**SANTA MONICA MOUNTAINS CONSERVANCY**

December 20, 2022

**ENV-2022-4003-EAF, ZA-2022-4002-DRB-SPP-F-HCA, 2401 Laurel Canyon Boulevard**

ZA-2022-4002-DRB-SPP-F-HCA, ENV-2022-4003-EAF, 2401 N. Laurel Canyon Blvd., APN 5565015016

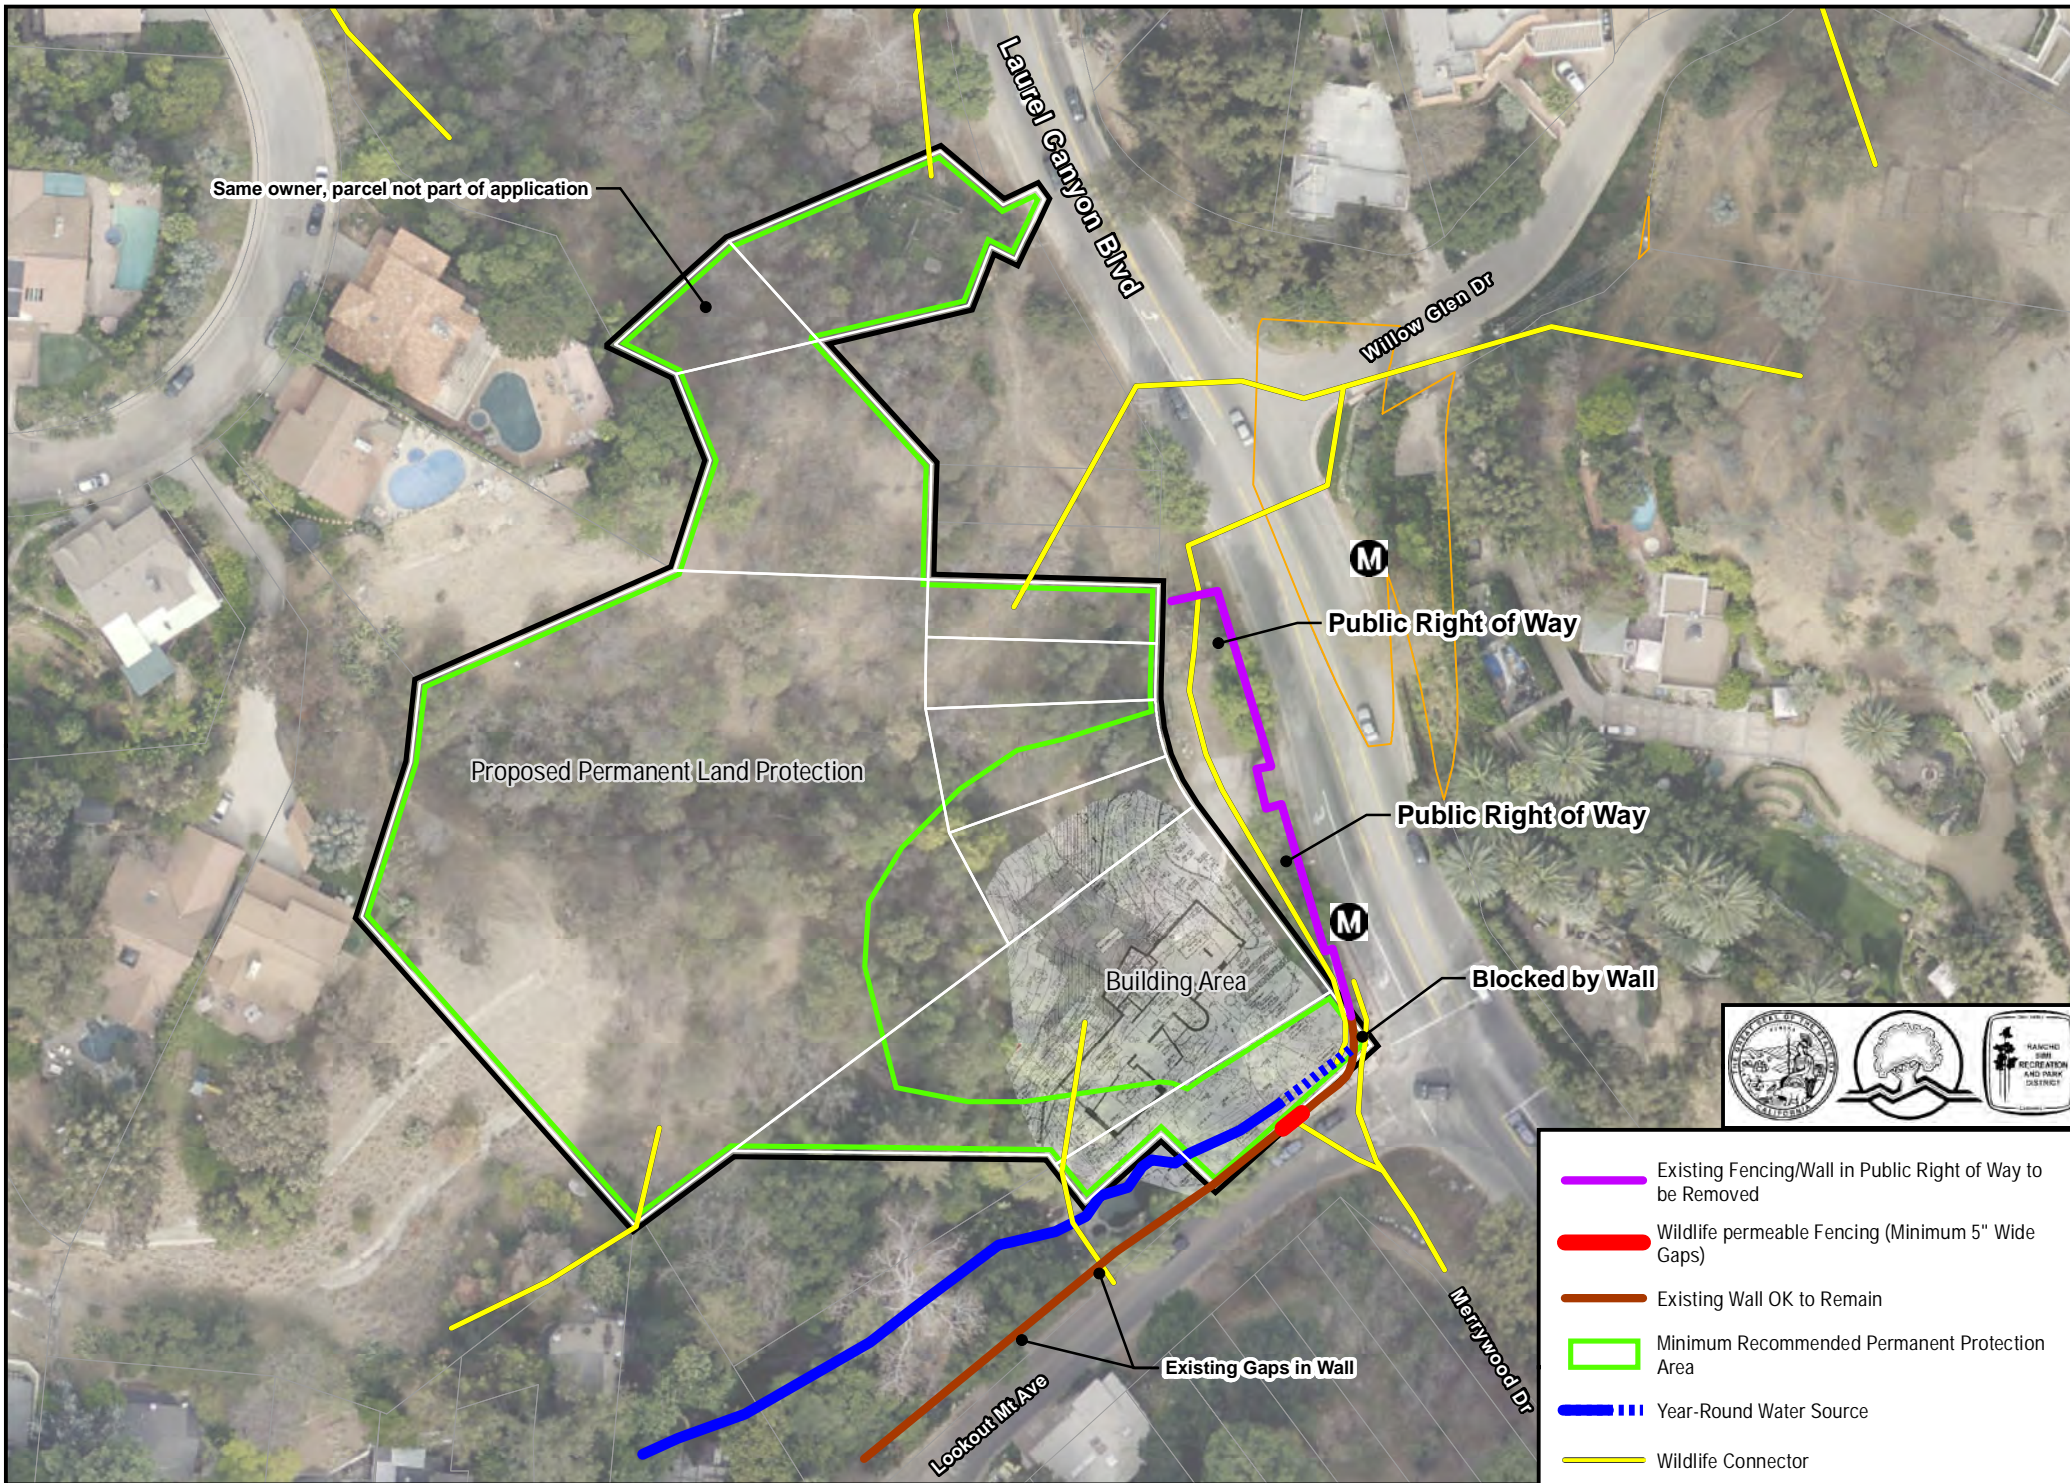
mammal access to the onsite perennial water and adequate wildlife movement potential through the property as shown on attached figures. Shucking these responsibilities to the upstream property is irresponsible without further analysis and legal cooperation from that property owner. The attached figures show what land needs to be permanently protected onsite.

1. Exclude all grading and any new improvements (including lighting) in the Conservancy-designed permanent protection area show on the attached figure.
2. Eliminate the second proposed driveway to Lookout Mountain Avenue.
3. Removal all existing private improvements (wall and fencing) from all Laurel Canyon Boulevard public rights-of-ways.
4. Eliminate all proposed new improvements (except minimum allowed driveway width) within Laurel Canyon Boulevard public rights-of-ways – including no lighting.
